INDESIT company

Model type:
LV460ABK

Commercial code:
F030379

Notices

n1045085: Introduction of new litre counter turbine integrated on air-break.

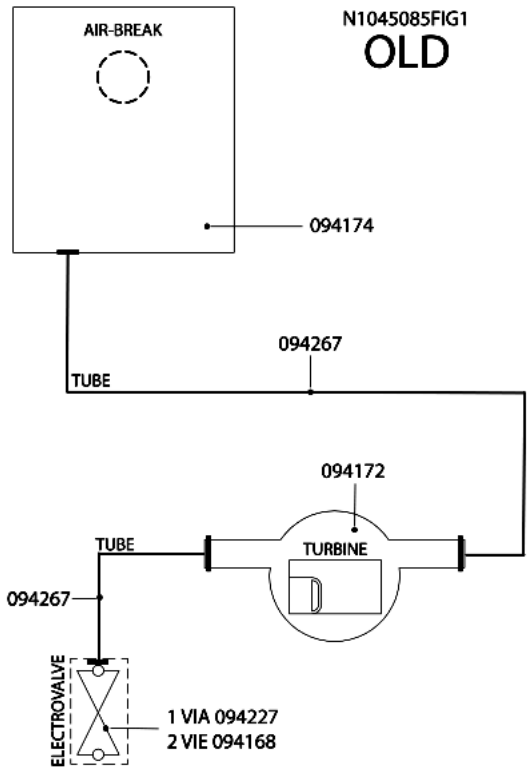
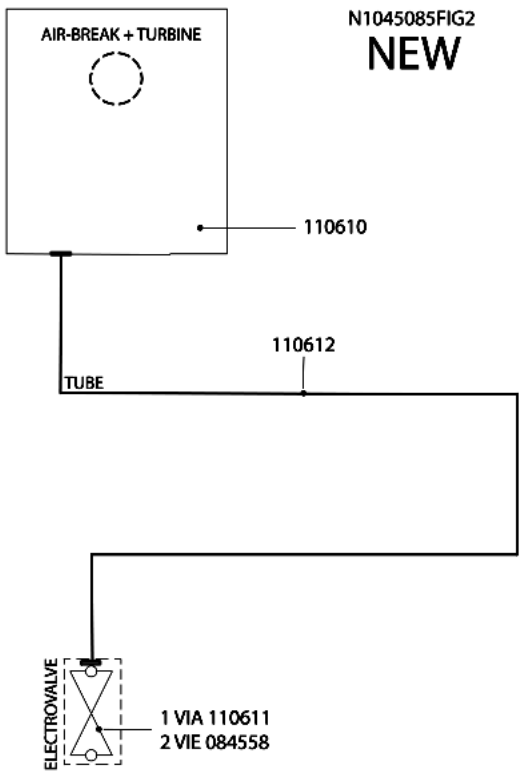
All dishwashers affected by this note have been equipped with a new litre counter turbine on the air-break.
Picture N1045085FIG1 illustrates the premodification structure, picture N1045085FIG2 the new structure.

AIR-BREAK:
new 110610;
premodification 094174;
the new item features a new integrated litre counter turbine and its water supply hose has a smaller diameter.

LITRE COUNTER TURBINE code 094172 has been eliminated.

SOLENOID VALVES:
new:
1-WAY code 110611;
2-WAY code 084558(Rohs 143737);
premodification:
1-WAY code 094227;
2-WAY code 094168;
the new solenoid valves have a smaller diameter drain hose fitting.

HOSES:
new solenoid valve hose/air-break code 110612;
premodification turbine hose/air-break code 094267;
premodification solenoid valve hose/air-break code 094267;
the new hose has a smaller internal diameter.

WIRING:
the litre counter turbine connecting cable is longer, but since the connector is the same, the new item can be used in place of the premodification one.

n1045087: Introduction of recessed heating element.

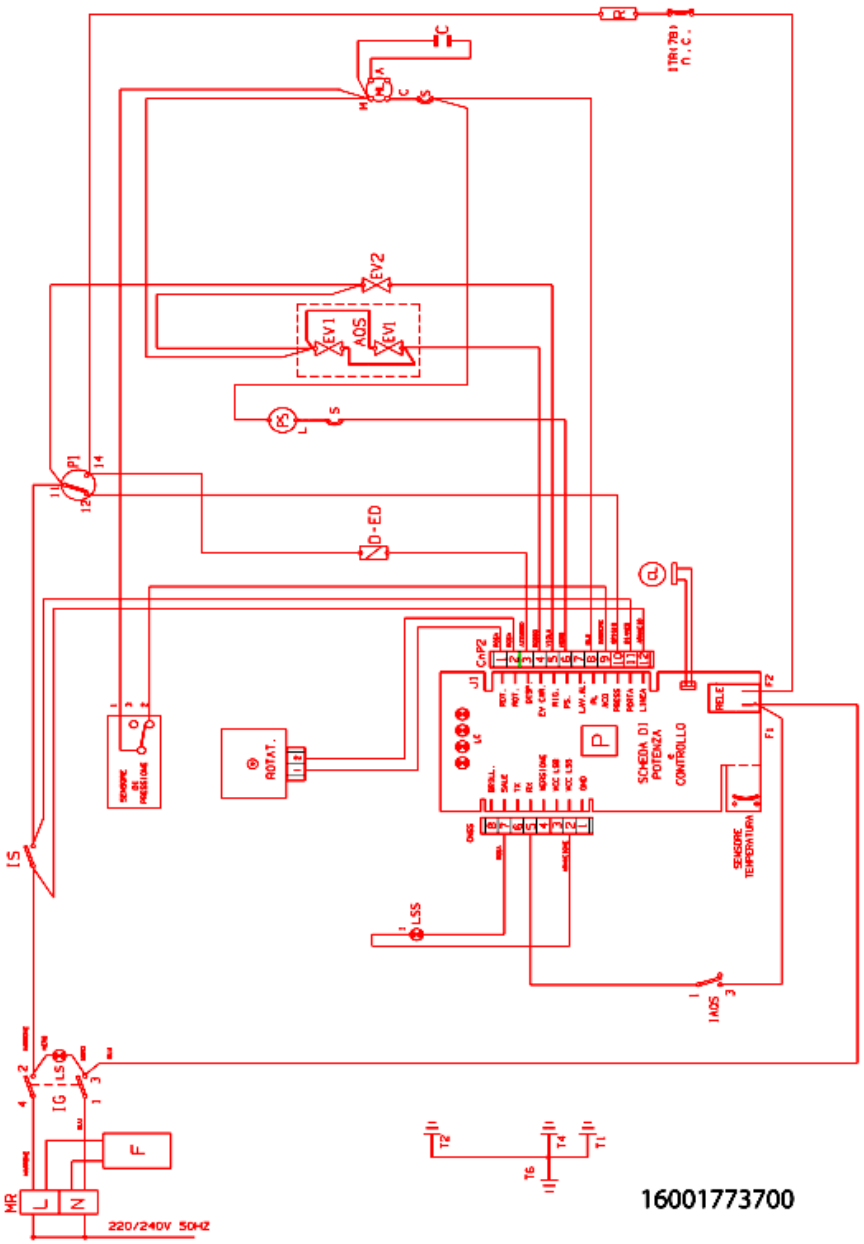
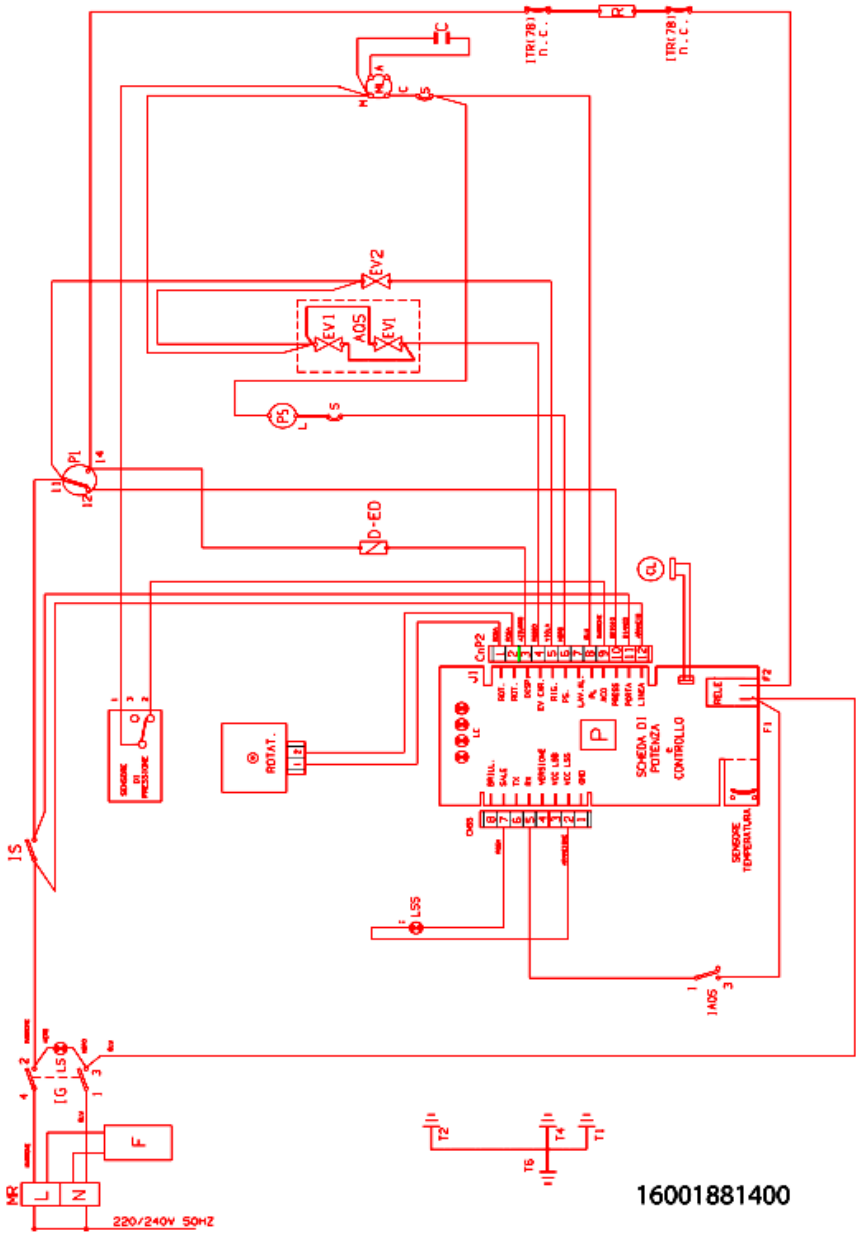
From serial no. 40624.0001, all dishwashers affected by this note have been equipped with a recessed heating element in place of the exposed one located inside the tank.
Given below are the codes of the items concerned:

ELIMINATED ITEMS:
nut + washer code 097871
o-ring seal code 063792
temperature probe code 063791
safety thermostat code 041086
exposed heating element code 066602
heater terminal protection code 074714
upper impeller supply tube code 056001
electrical pump connection tube - upper impeller supply tube code 076233
heater bracket code 054872

INTRODUCED ITEMS:
recessed heating element code 074000
upper impeller supply tube code 094152
heater coupling support code 078394
electrical pump connection tube - heating element code 057710

LV460ABK (comm. code 30379)
Wiring Diagram: premodification 16001773700 new 16001881400
Wiring: premodification 110482 new 112488
